MEMORANDUM

Date: ~~April 25, 2024~~ November 19, 2024 March 14, 2025
To: Aditya Jatar, BOE
CC: Kaylie Coleman, Bryan Golden,
Transportation and Public Works Department
Reference: **200 E Riverside PUD Traffic Impact Analysis** (C814-2023-0057) – 200 E Riverside Dr,
Austin, Final Memo

Figure 2. Improvement Extent

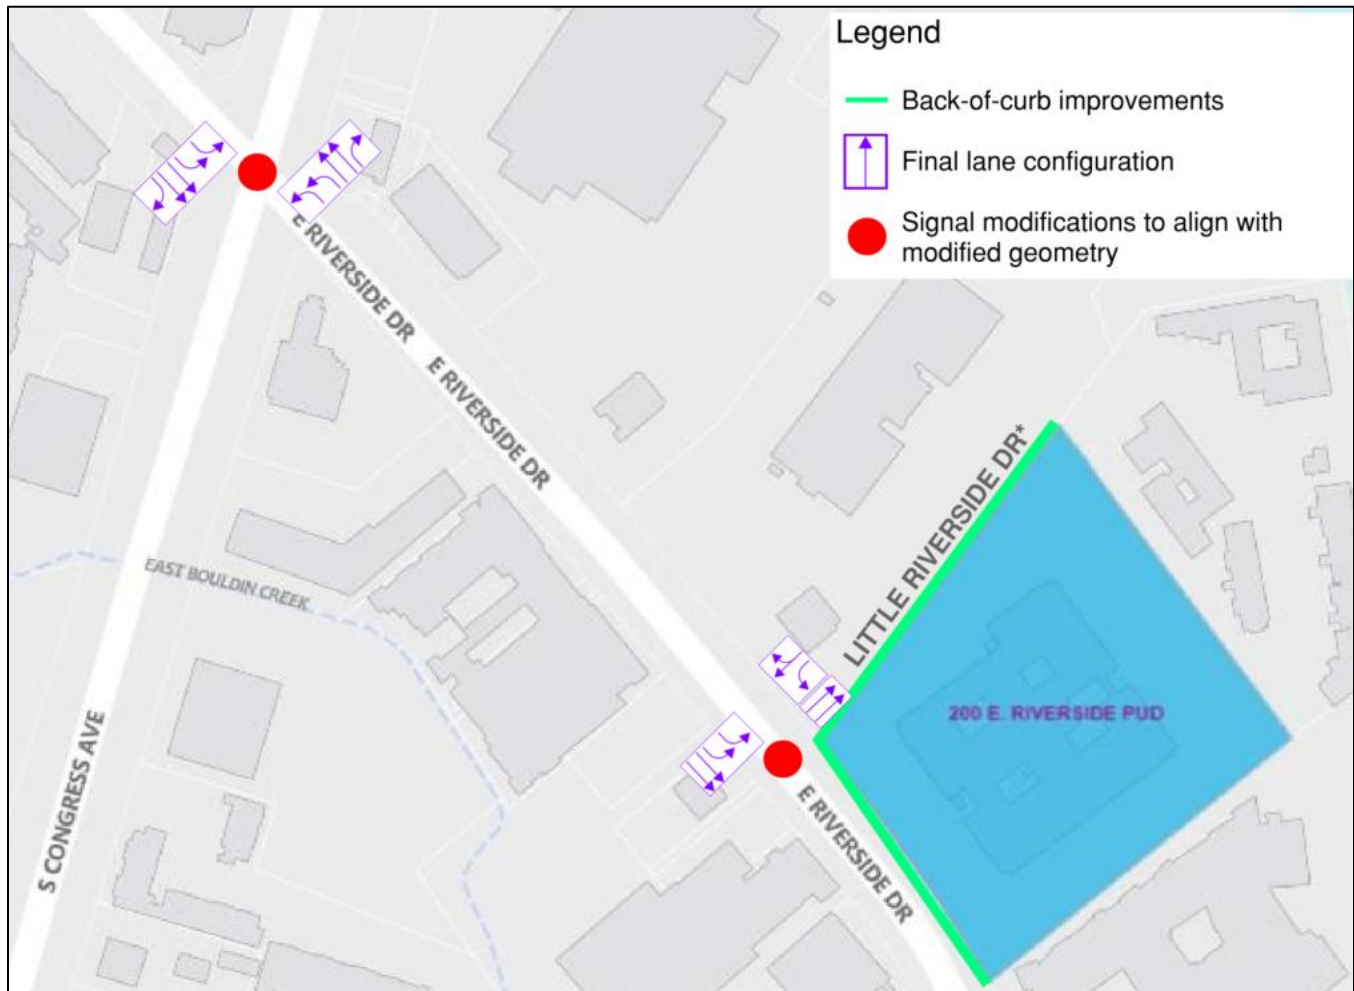
<p><i>Table 2. Improvements Identified in the TIA</i> (This will be reevaluated at the time of the site plan when more information about the site and Project Connect is available.)</p>	
Name	Improvement
E Riverside Dr & Little Riverside Dr* (See Figure 2 for the improvement extent)	Restripe existing pavement to 1L, 1 TR along SB Little Riverside Dr* approach to accommodate SB LTL on Little Riverside Dr*
	Provide 1 additional LTL to create dual left turn lanes along EB approach
	Widen NB approach with merge taper along Little Riverside Dr* to provide additional receiving lane for EB to NB dual left turns
	Signal re-timing, lane assignment sign, signal head modification as needed to align with modified geometry
E Riverside Dr & S Congress Ave (See Figure 2 for the improvement extent)	Install 1 additional LTL to create dual left turn lanes along EB E Riverside Dr approach
	Install 1 additional LTL to create dual left turn lanes along WB E Riverside Dr approach

Install 1 RTL along WB E Riverside Dr approach
	Signal re-timing, lane assignment sign, signal head modification as needed to align with modified geometry
Back-of-curb Improvements (See Figure 2 for the improvement extent)	Design and construct back-of-curb improvements with the coordination of TPW along site frontages on Little Riverside Dr* & E Riverside Dr
